PRODUCT CHANGE NOTICE

PCN # SIM8050 E PCN  
20150930

SIM8050-6-0-14-XX-A

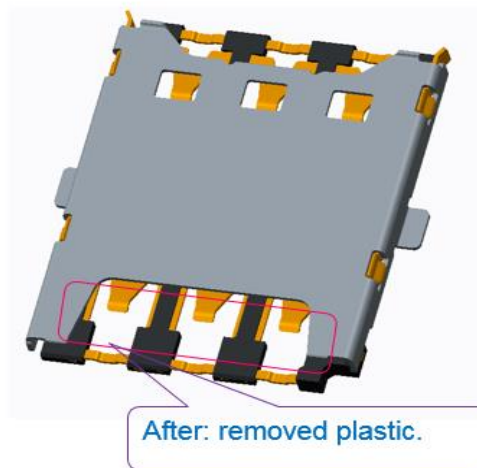
Removal of the plastic cross bars:

Process improvements.
